| AMENDMENT OF SOLICITATION/MODIFICATION OF CONTRACT  |  |                                  |  | 1. CONTRACT ID CODE   |  | PAGE OF PAGES<br>1   2                                |  |
| 14. DESCRIPTION OF AMENDMENT/MODIFICATION (Organized by UCF section headings, including solicitation/contract subject matter where feasible.)<br>AMENDMENT NO. 0001 to DACA65-01-B-0005   |  |                                  |  |   |  |   |  |

## 2. Technical plans and specifications are amended.

**NO. 1**

SKETCH C-30.1

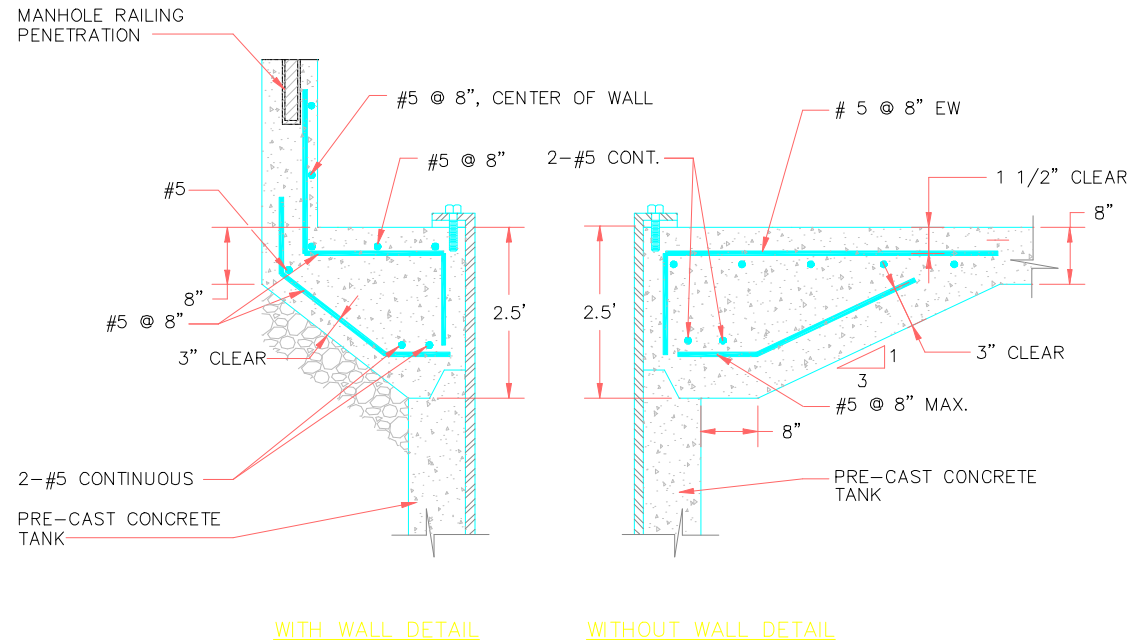
#### **5. Sheet C-30**

See Sketch C-30.1 attached.

PUMP STATION CONCRETE SLAB AT  
PRE-CAST CONCRETE TANK DETAIL
